V2500-A1/A5 SERIES NACELLE SERVICE BULLETIN

This document transmits Revision 1 to Service Bulletin EV2500-79-0065

NACELLE - POWERPLANT - INTRODUCTION OF IMPROVED OIL QUANTITY TRANSMITTER

SB-79-31-15-01

Removal and Installation of Oil Quantity Transmitter Figure 1

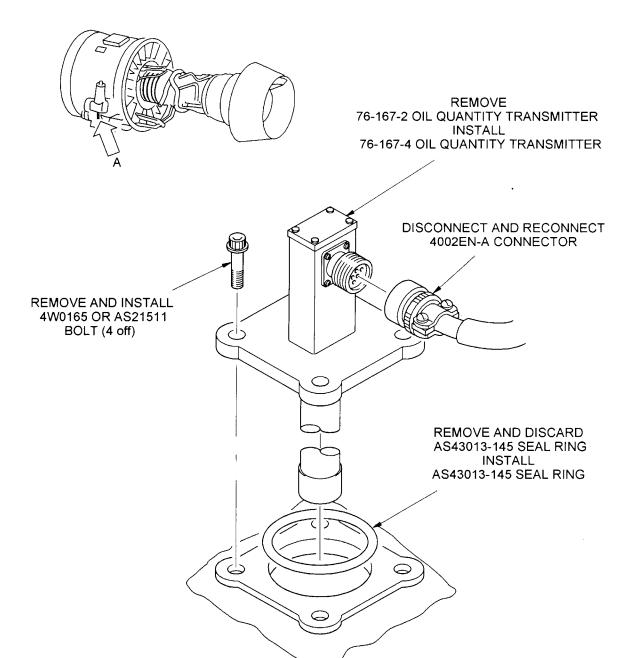
(1) The 4002EN-A connector is disconnected and the bolts that attach the 76-167-2 Oil Quantity Transmitter are removed. A new or replacement 76-167-4 Oil Quantity Transmitter and new Seal is then installed and reconnected.

- (1) Remove the Oil Quantity Transmitter 76-167-2 as instructed in the Aircarft Maintenance Manual, Chapter Section 79-31-15 Removal/Installation. (Refer to Figure 1)
- R (2) Return the Oil Quantity Transmitter 76-167-2 to Vibro-Meter Inc. for re-work in accordance with Meggitt/Vibro-Meter Service Bulletin 79-31-15-01 Rev 2. Refer to Section 2.D. for shipping details.
 - (3) Install the new 76-167-04 Oil Quantity Transmitter as instructed in the Aircraft Maintenance Manual, Chapter Section 79-31-15 Removal/Installation.

Figure 1: Serial Number Description

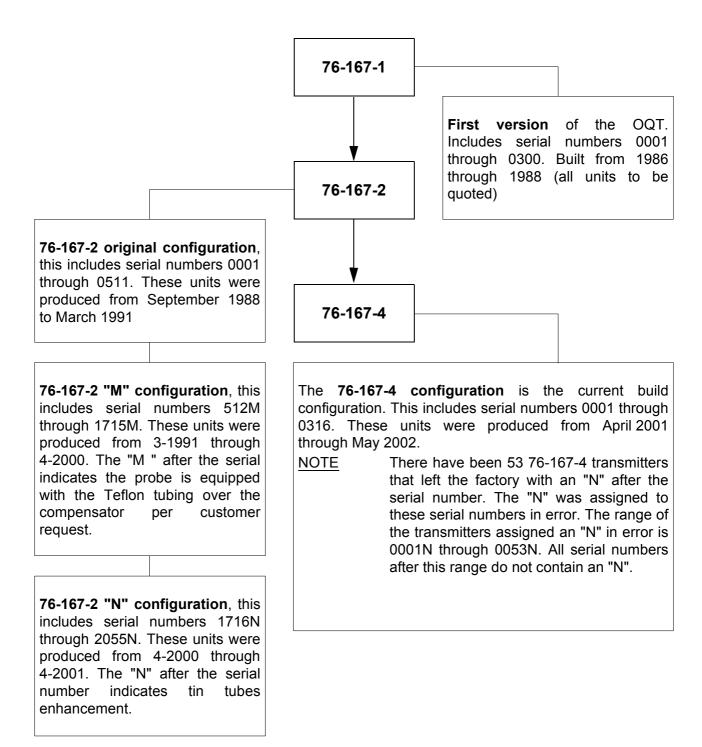
- (1) The various configurations of the OQT are shown in Figure 1 : Serial Number Description, page 3.
- (2) For more details, refer to section H., or get in contact with one of the Vibro-Meter Customer Support Centers as follows:

All 76-167-2 transmitters (original configuration or "M" configuration) that are returned to Vibro-Meter Inc. for repair will receive tin tubes free of charge. These modified transmitters will receive an "N" stamped after the transmitter's serial number. Operators who wish to incorporate the full upgrade to a 76-167-4 will receive the transmitter with a new part number and new serial number.
